L'Anse Creuse Public Schools

**Bid Package 25-01 : Flooring Replacement at Lobbestael,
Tenniswood & Yacks Elementary Schools**

ADDENDUM NO. 1

Project Name: 2024 Bond Projects – Bid Pack 25-01
Flooring Replacements Phase 1

SHEET NO.
A1-03

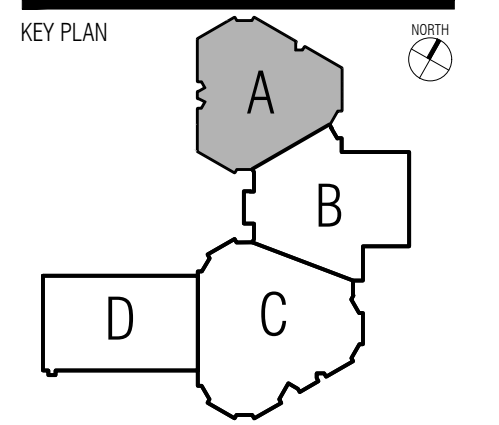
Item A4 A0-03, A9-02 – Moved stage stairs in Cafeteria from Alternate 2 to base bid.
Item A5 A1-01, A1-03 - Clarified locations of ¼ round demolition
Item A6 A1-02 – Revised demolition in vestibule to be Ceramic Tile

SHEET NO.
A1-01

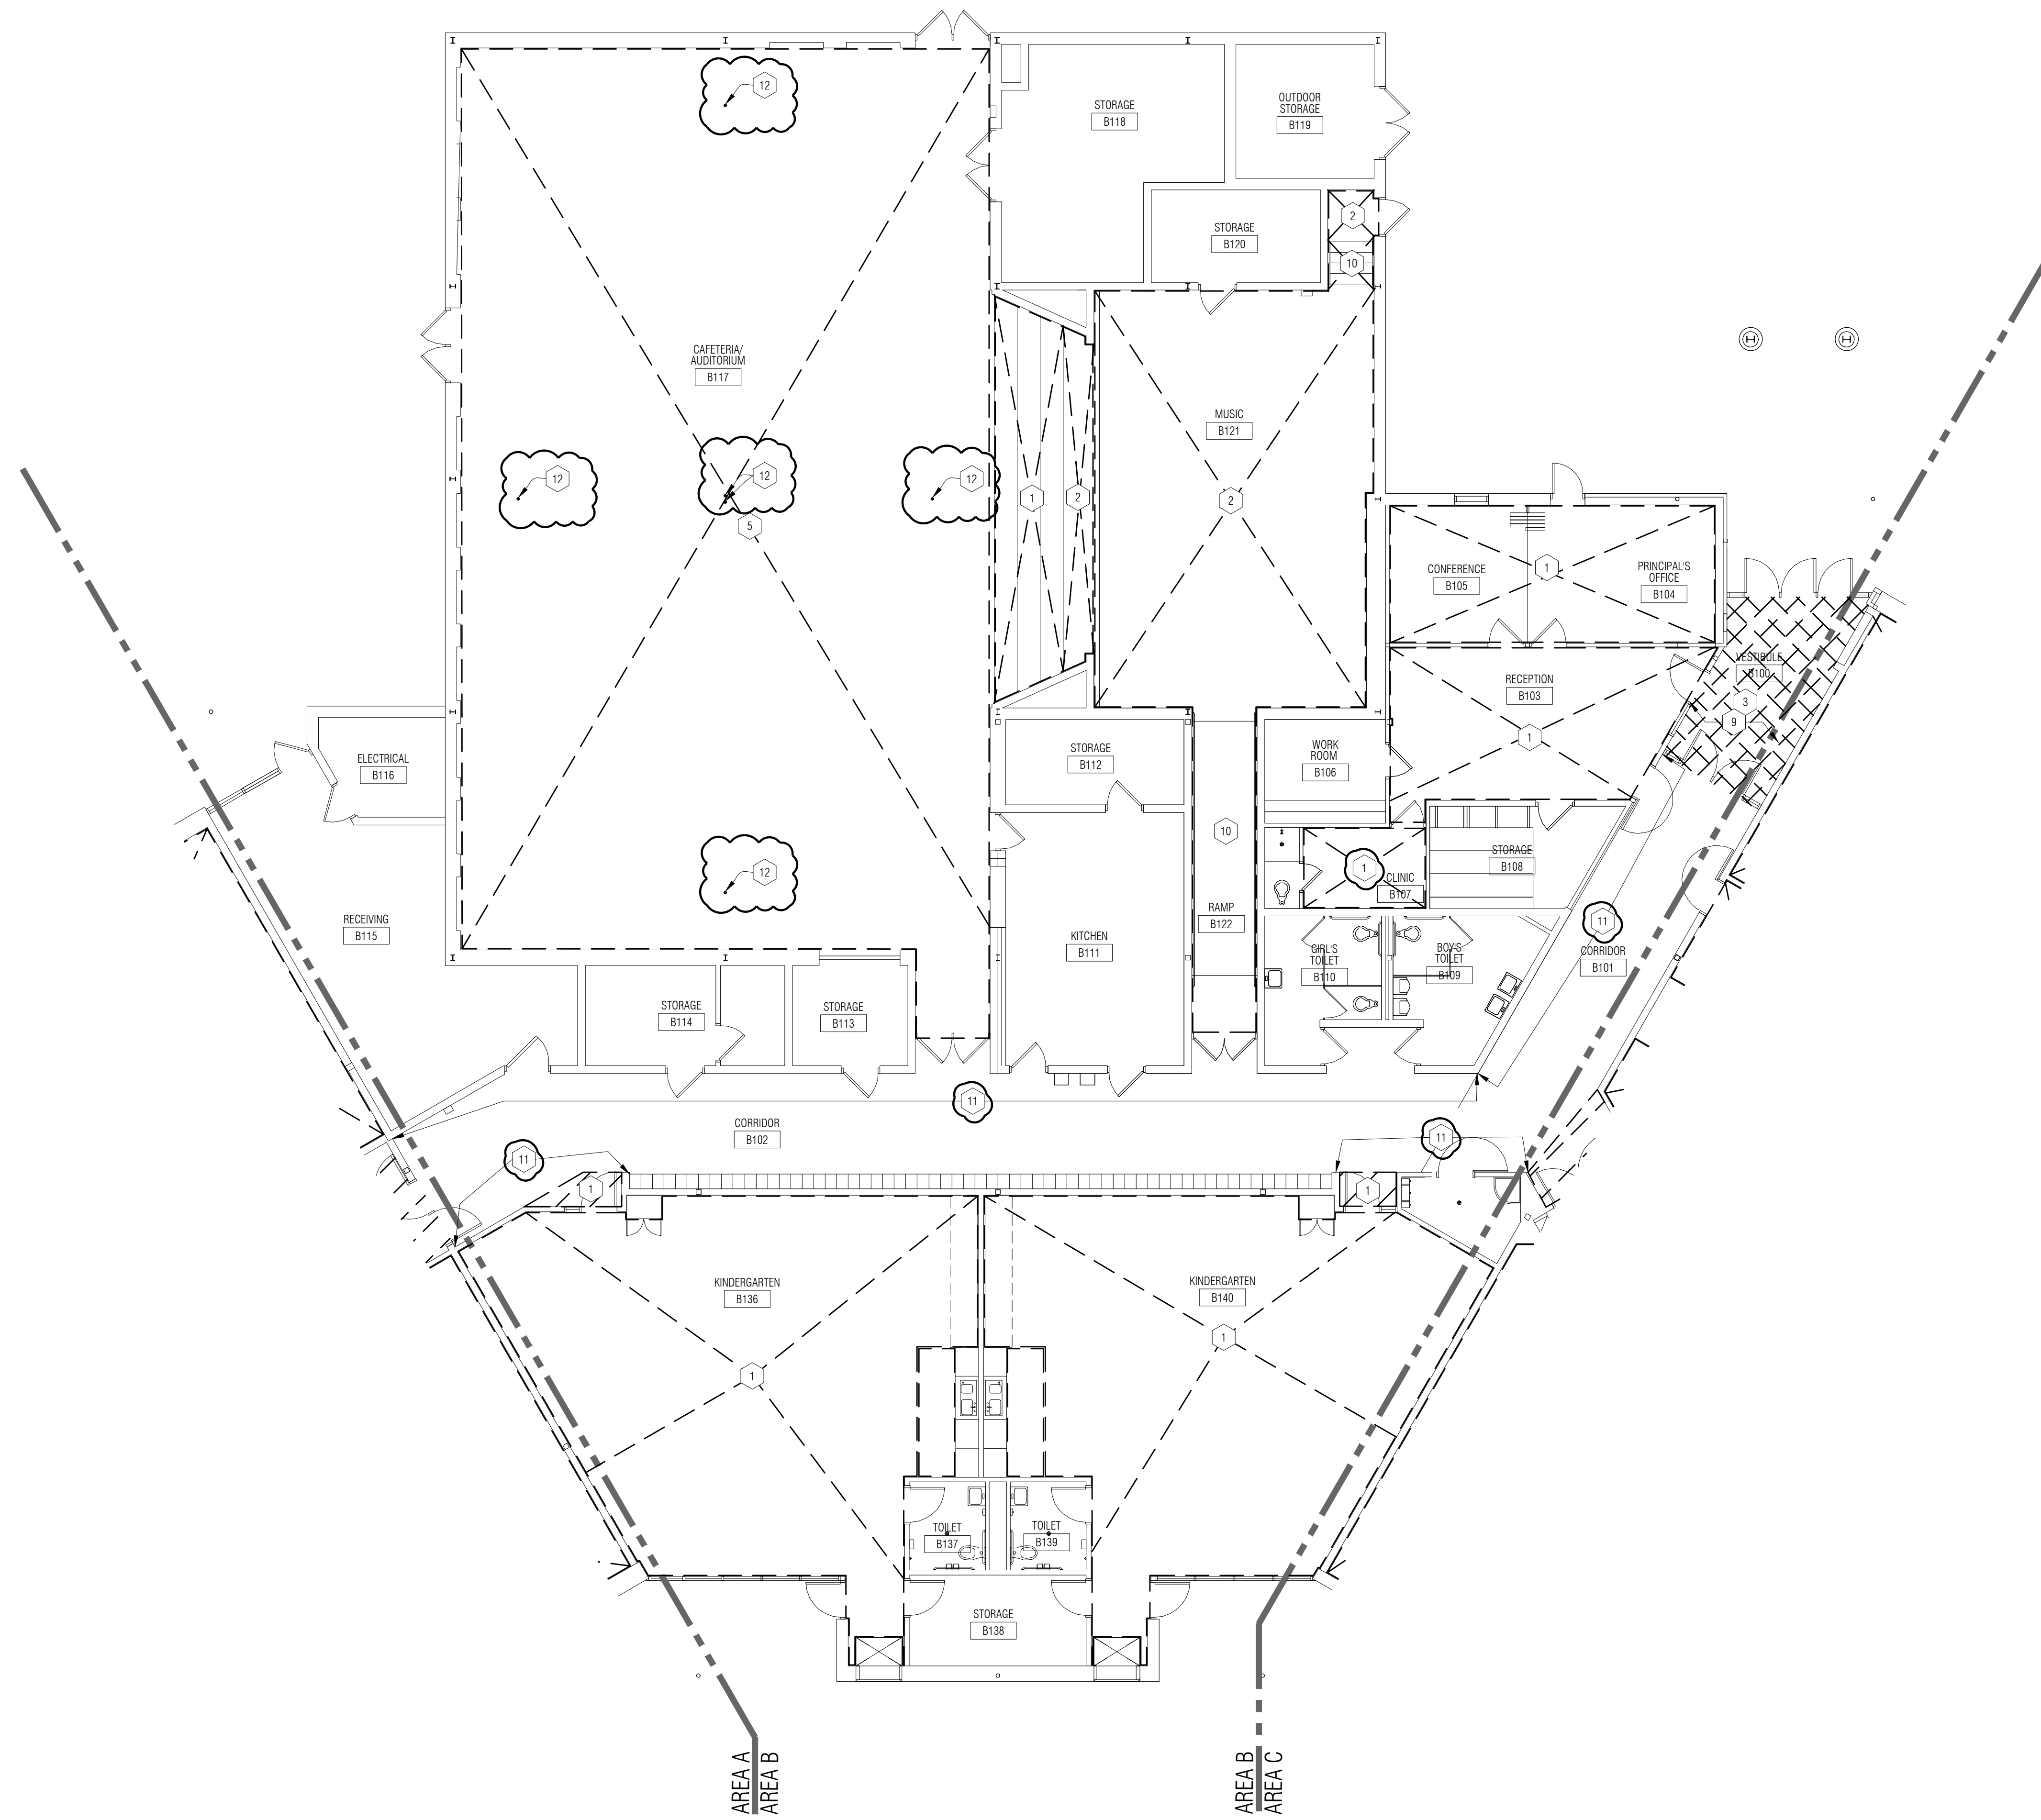
Item B3	A0-03 - Revised floor transition details
Item B4	A0-03, A9-02 – Moved stage stairs in Cafeteria from Alternate 2 to base bid.
Item B5	A1-01, A1-03 - Clarified locations of ¼ round demolition

**DEMO FLOOR
 PLAN -
 AREA B**

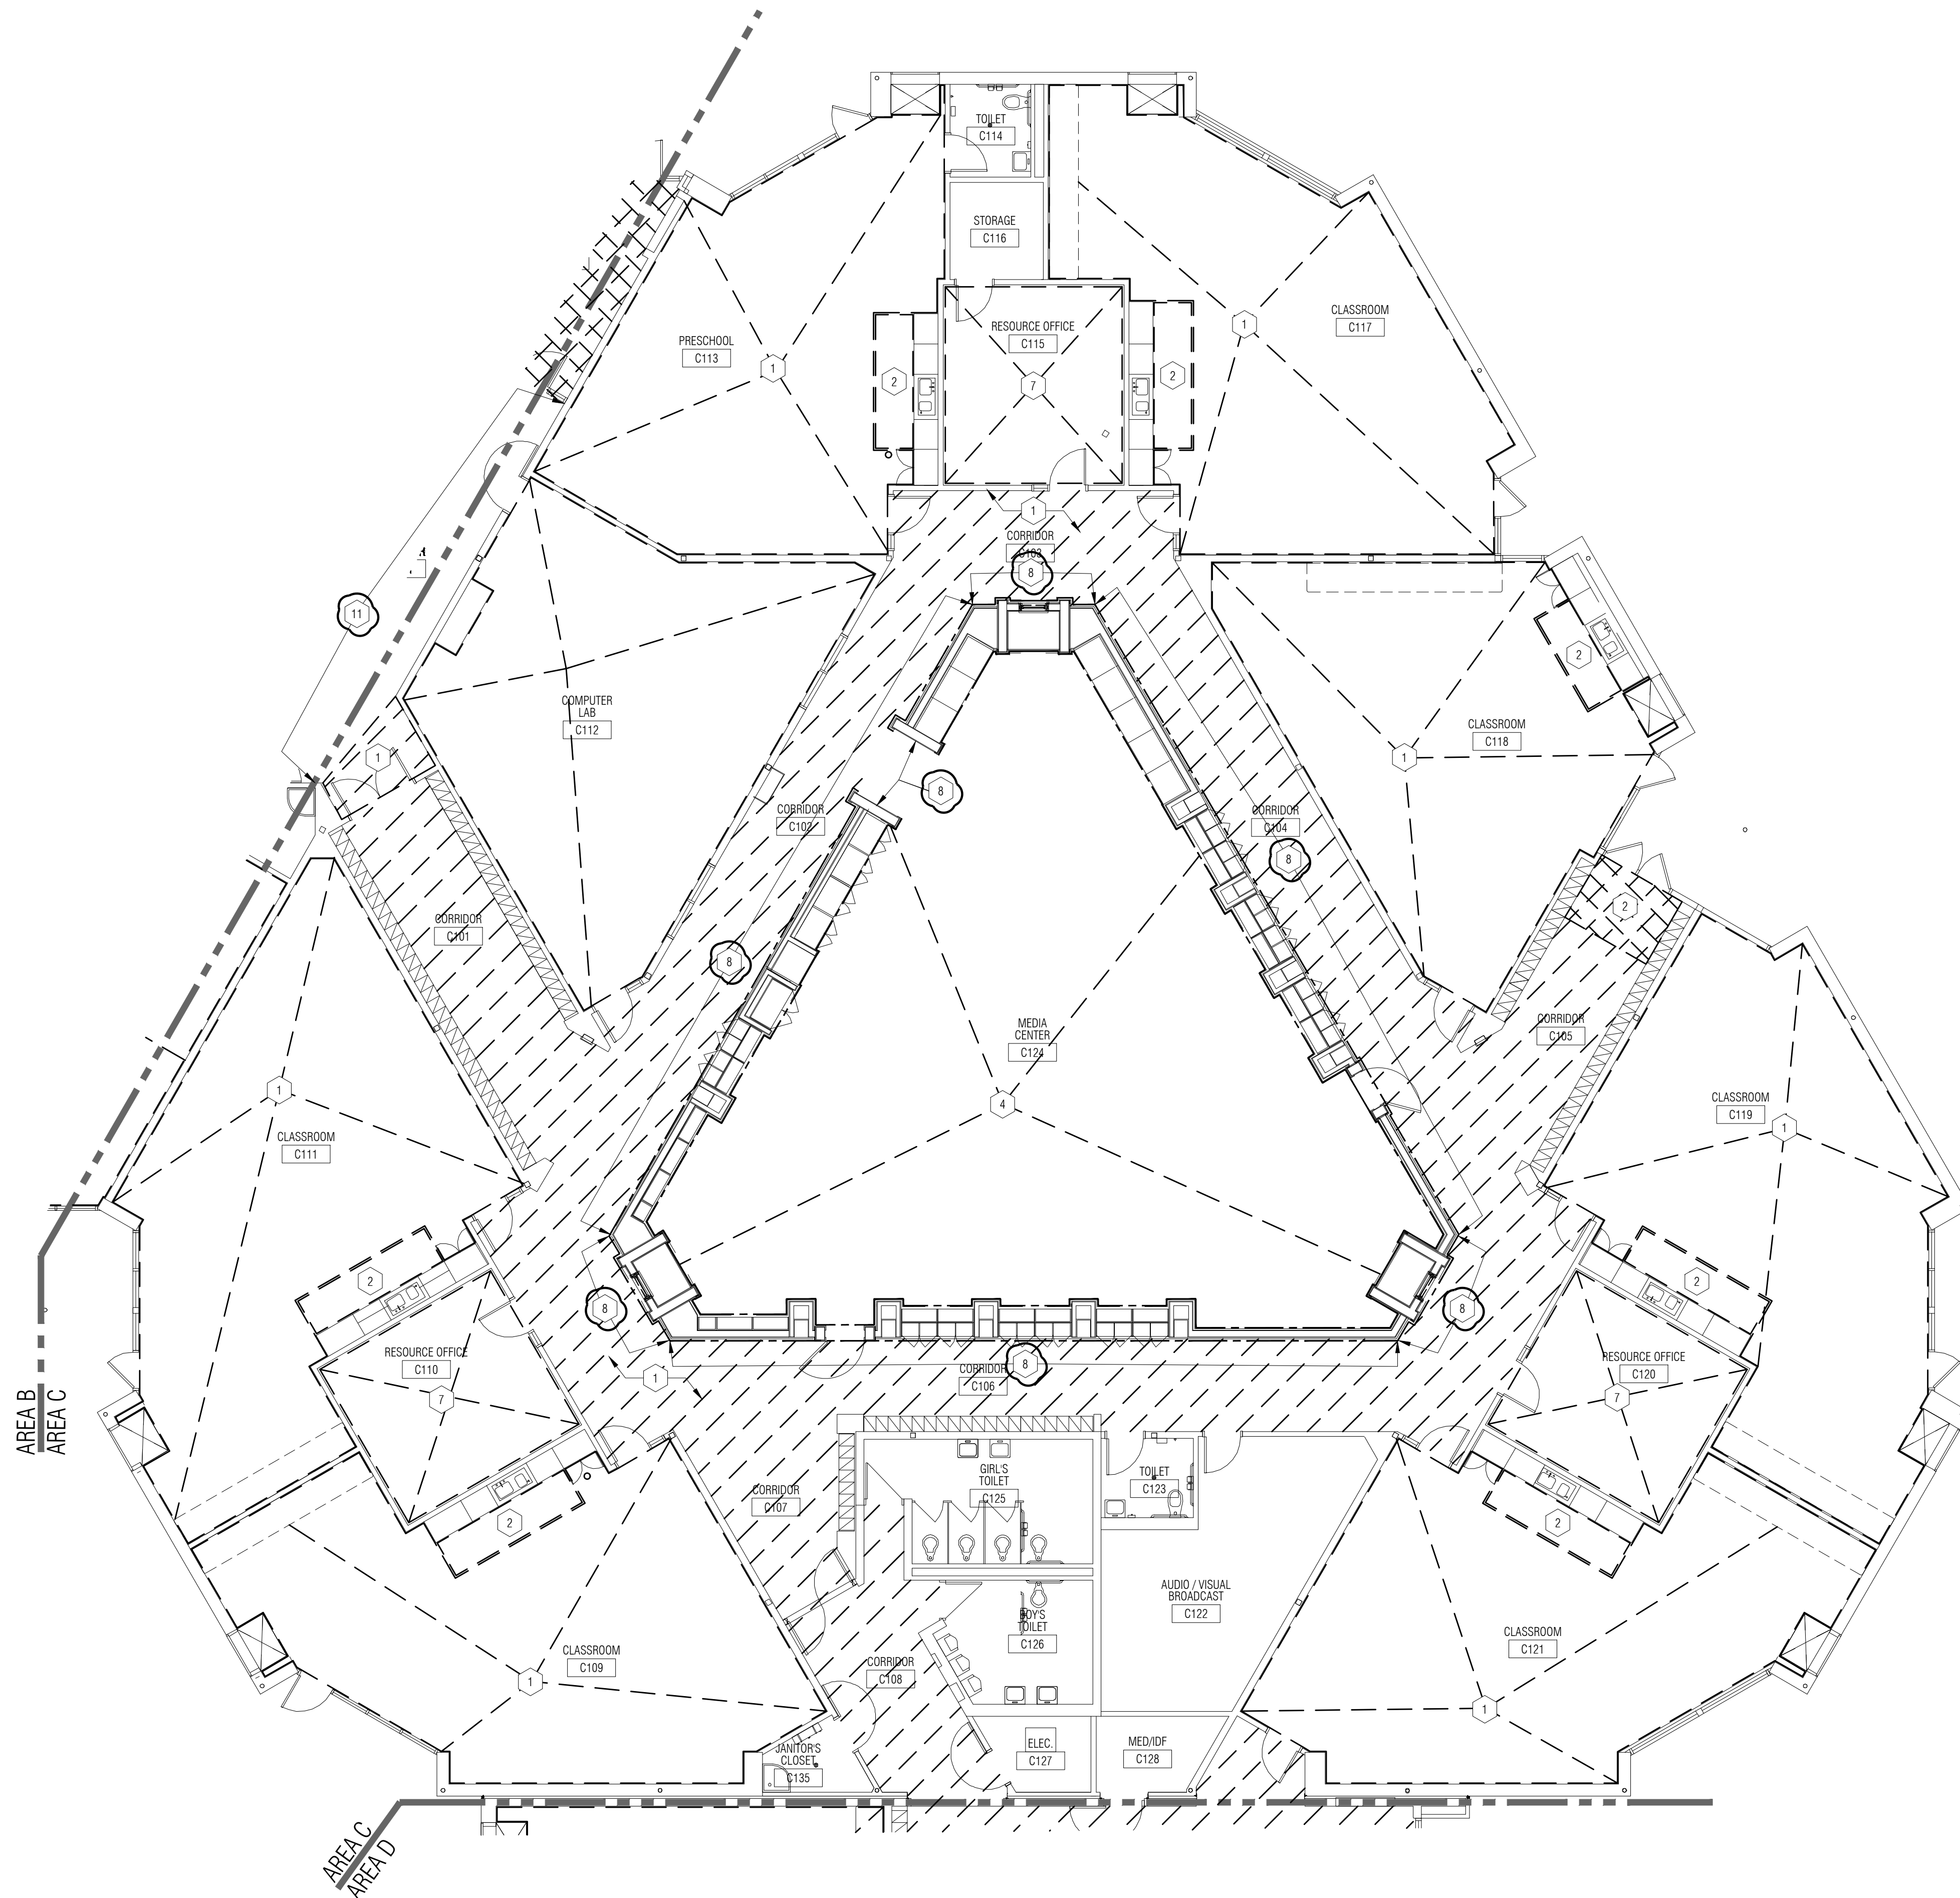
Item B6	A1-02, A1-03 – Removed wall base adjacent to existing terrazzo in corridors
Item B7	A1-02, A9-02 – Added demolition of floor equipment sleeves from Cafeteria
